**COMBINED FIELD INSPECTION**

**T.I.P. #:** R-5901

SUBJECT: Project: R-5901 [Intersection Improvements at NC 89 (W. Pine St.) and  
SR 1397 (Round Peak Church Rd./Oak Grove Church Rd.)] Surry County  
WBS: 48416.1.1

**Request for Design Exception**

REVISIONS

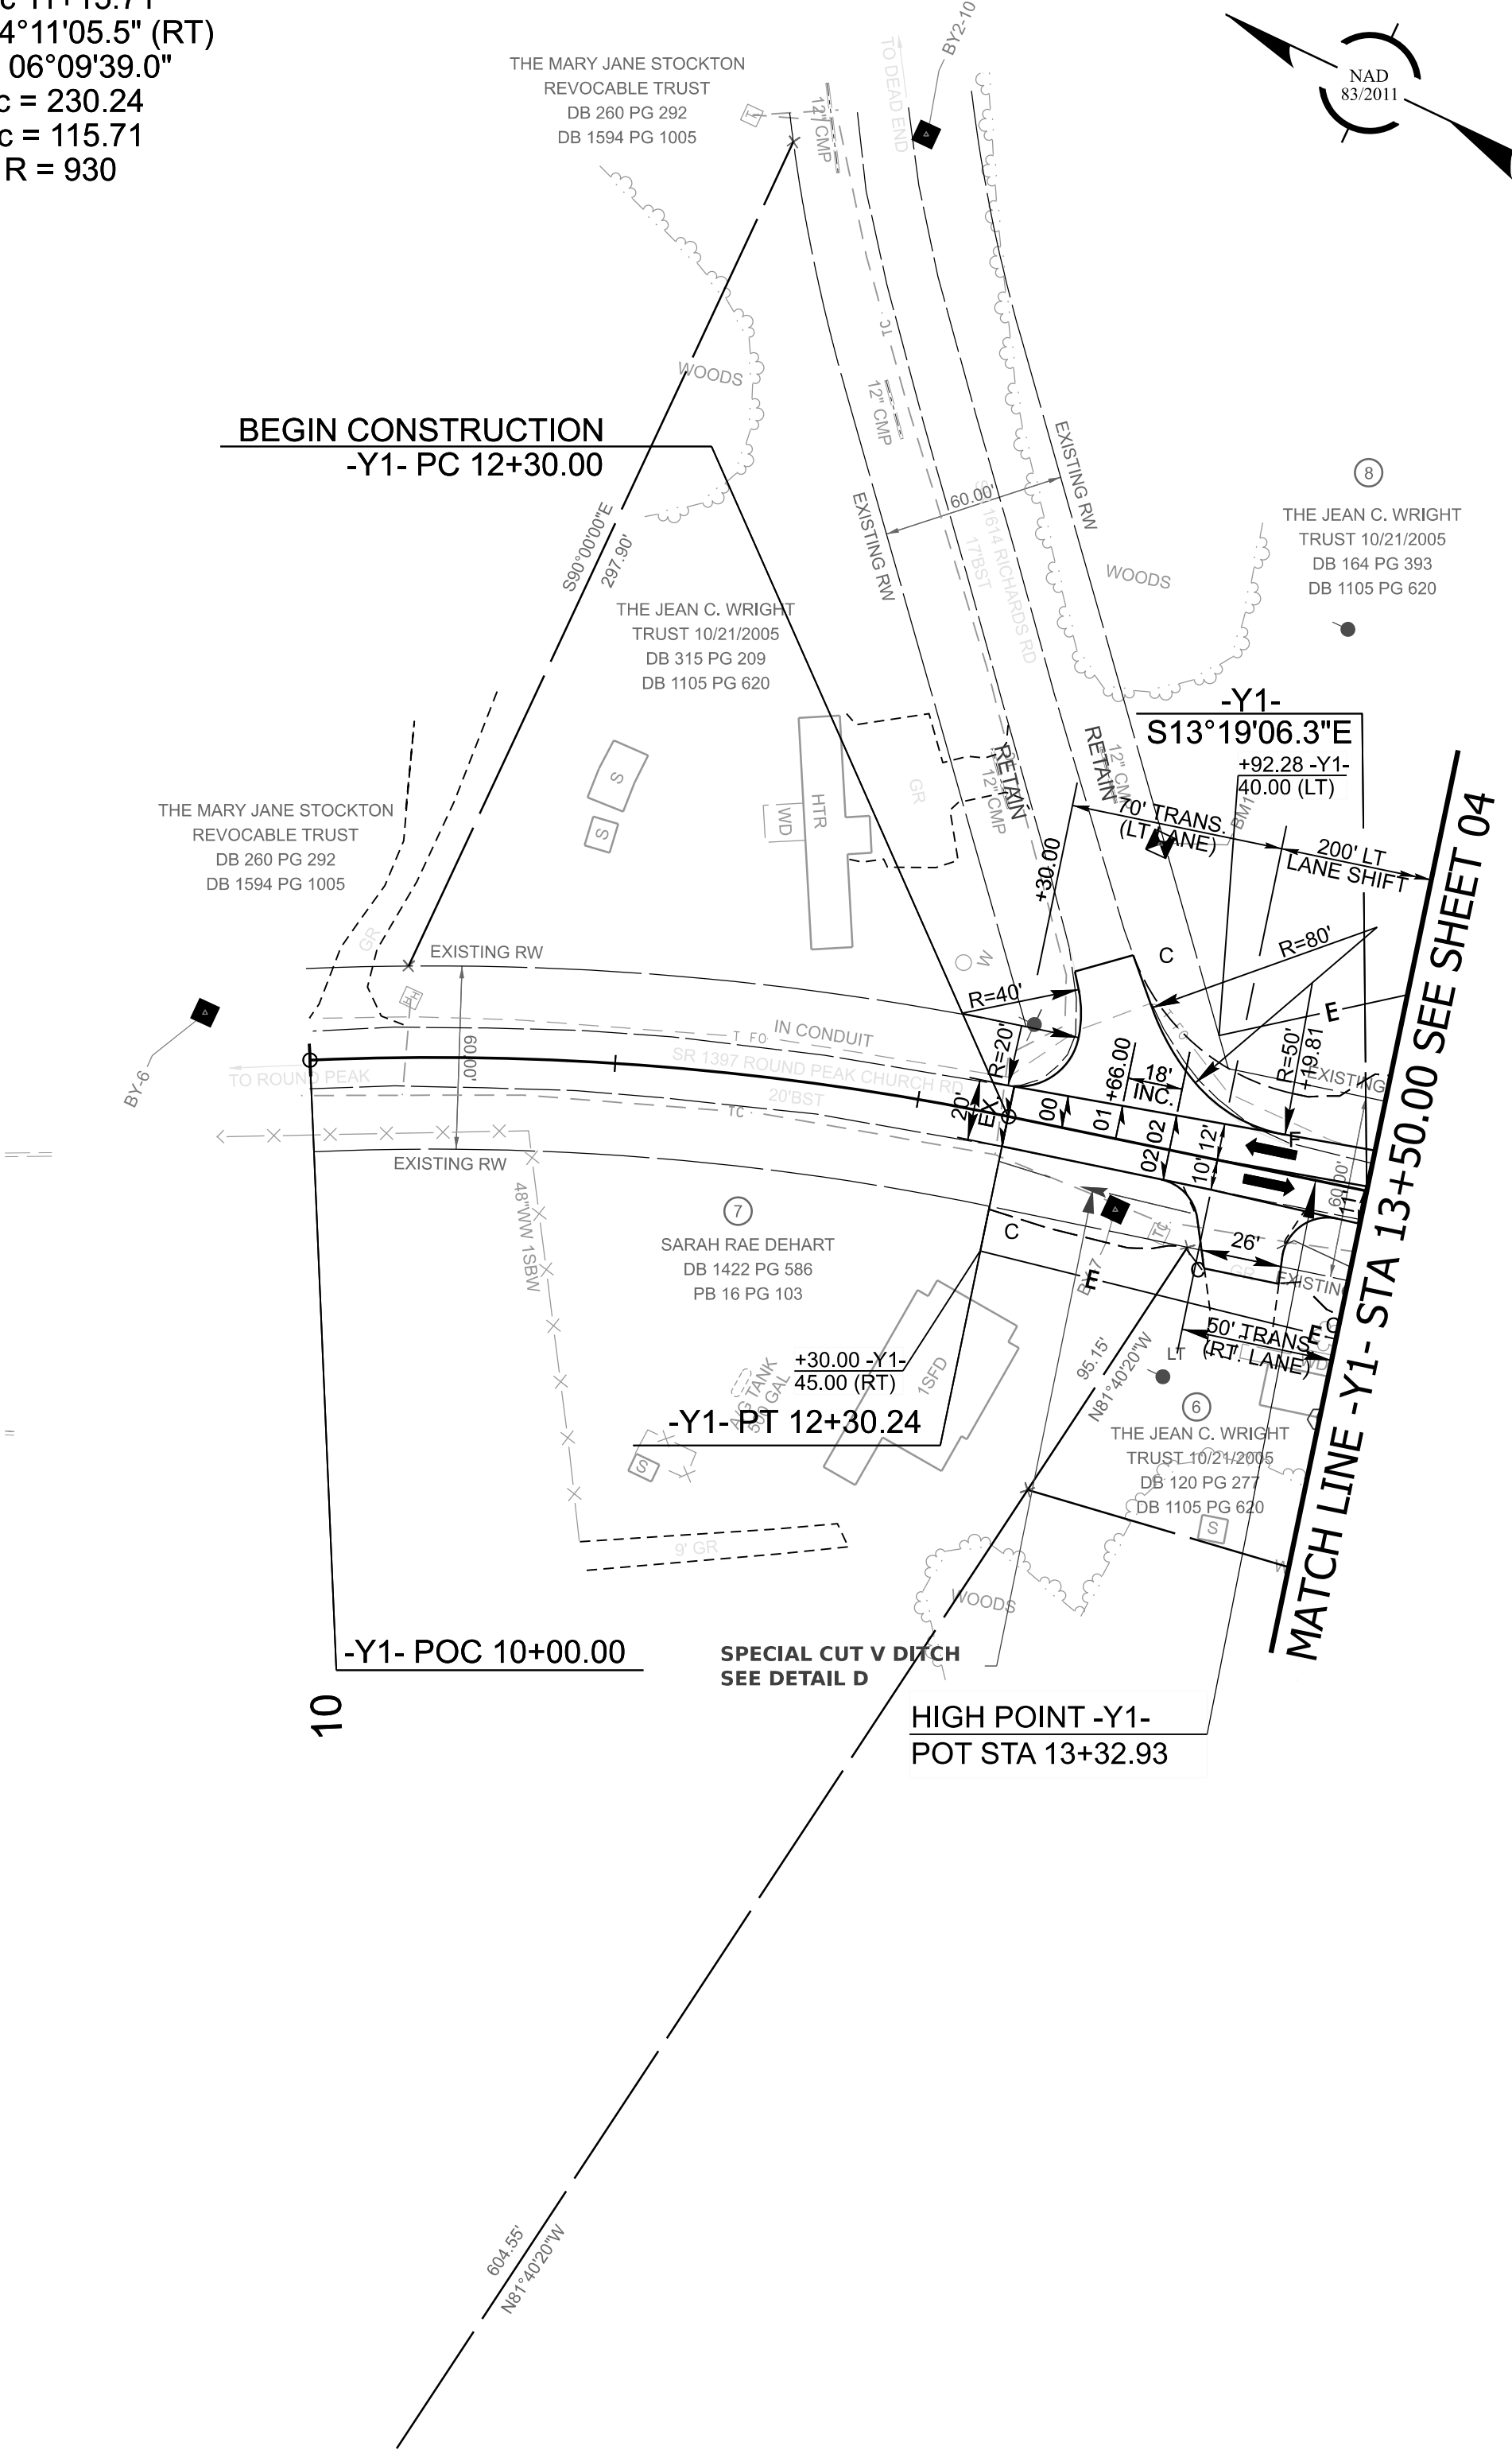
- Location #1:** *(maximum grade)* -L1- (NC 89) Sta. 12+00.00 to 15+30.00,  
varies +6.5443% to +5.0000%

**Location #2:** *(maximum grade)* -L2- (NC 89) Sta. 15+14.53 to 20+10.00,  
varies -5.0000% to -6.0000%

Minimum AASHTO Dimensions:  
**Maximum Grade for -L1- and -L2-**  
AASHTO: 5.0000%  
*The proposed maximum grades on -L1- and -L2- meet 35-45 mph criteria in rolling terrain or 50 mph in mountainous terrain.*

Dimensions Proposed:  
Proposed: (varies) 5.7000% to 6.5443%

**With regards to the maximum grades on NC 89, the steeper (uphill) grades approaching the proposed roundabout on the west and east legs are anticipated to work in tandem with the new roundabout design to encourage vehicles to decelerate as they approach. Although the grades exceed the AASHTO maximum to tie into the existing grades on NC 89, the proposed grades will be lessened within the immediate roundabout approach (2.5% on L1, 1.77% on L2) to provide a flatter slope for vehicles as they come to a yield/stop condition. As part of the proposed improvements, the posted speed limit on NC 89 is also planned to be lowered to 45 mph from west of the proposed roundabout at NC 89 and Beulah Rd to the east side of the NC 89/I-77 interchange.**

-Y2-

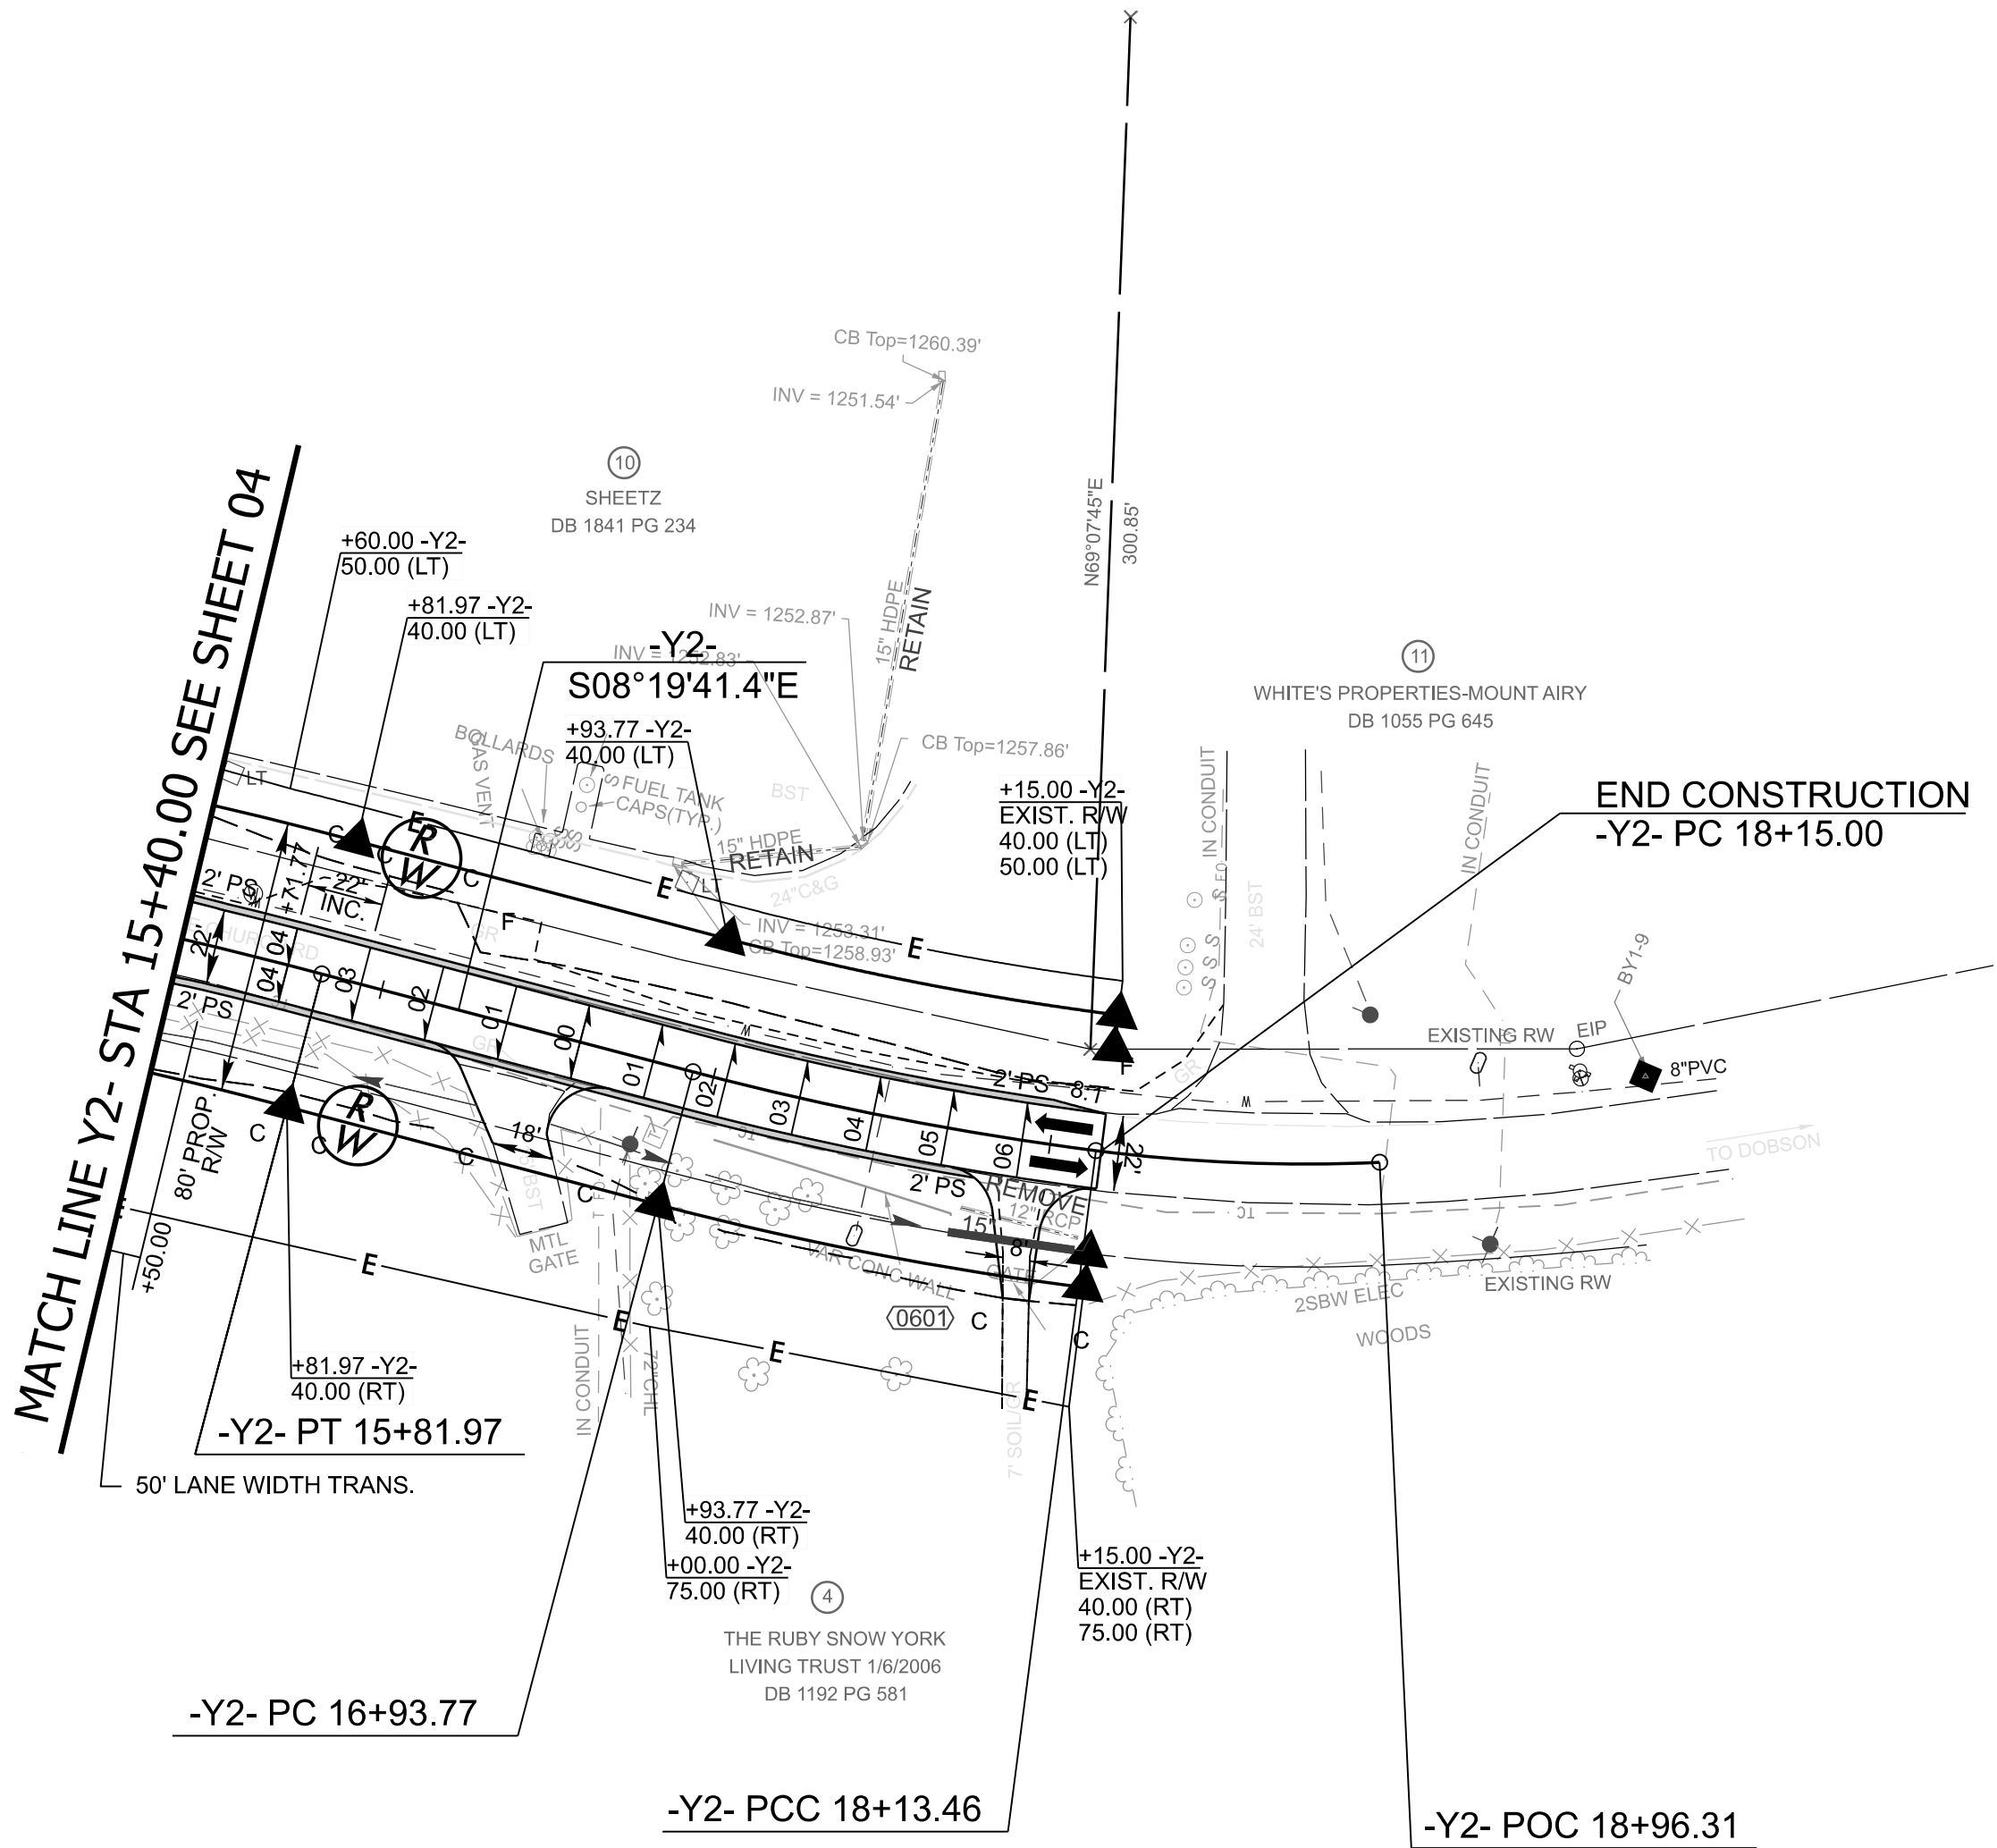
**Location #3:** *(stopping sight distance for crest vertical curve)* -Y1- SSD=320'  
(meets 40 mph)

**Location #4:** *(stopping sight distance for crest vertical curve)* -Y2- SSD=324'  
(meets 40 mph)

**Stopping Sight Distance for -Y1- and -Y2-**  
AASHTO: 425'  
*The proposed SSD on -Y1- and -Y2- meet 40 mph design speed.*

Proposed: -Y1- 320' /-Y2- 324'

- The Division does not believe that a grade change (*while allowing for the roundabout to remain within recommended design standards*) will improve the sight-distance enough on -Y2- to fix the issues at the Sheetz business. In the Teams meeting, the drawbacks of

**To mitigate the lower available stopping sight distance on Y1 and Y2, the following actions are proposed. For Y1, an advisory speed panel will be added, and the appropriate advisory speed will be determined once the project is placed in its final alignment. For Y2, the speed limit will be lowered to 45 mph and the sign will be posted in advance of the lessened sight distance area. Additional advanced signage will also be provided on each approach to Y1 and Y2 in conjunction with the conversion of the intersection to a roundabout. The extents of the proposed speed limit change, advisory speed panel signage, and other additional signage will need to be further coordinated with the Regional Traffic Engineer as the plans are developed. A field review may also be completed after project construction is completed to evaluate the operation of the facility and identify if other mitigation measures are needed.**

extending the splitter island past the 1<sup>st</sup> driveway at -Y2- Sta.14+45 was discussed, and we agree not to block this access with a splitter island. We do want to maintain left-in/left-out movements for this access. [Understood, the full movement access for this driveway has been maintained.](#) The Division team has discussed possible mitigation issues, and it is not supported for the Division to add additional signage/flashing beacons or move the access. The sight distance issues with the current statutory speed were pre-existing at this developed site prior to this project design and it would be outside of the intended scope of the allotted project funds to resolve this. However, please know that our final decision to try and alleviate the stopping sight distance issue at this location has been for the Division Traffic Unit to reduce the speed on this -Y2- leg. We are intending to drop it down to a 45mph posted speed.
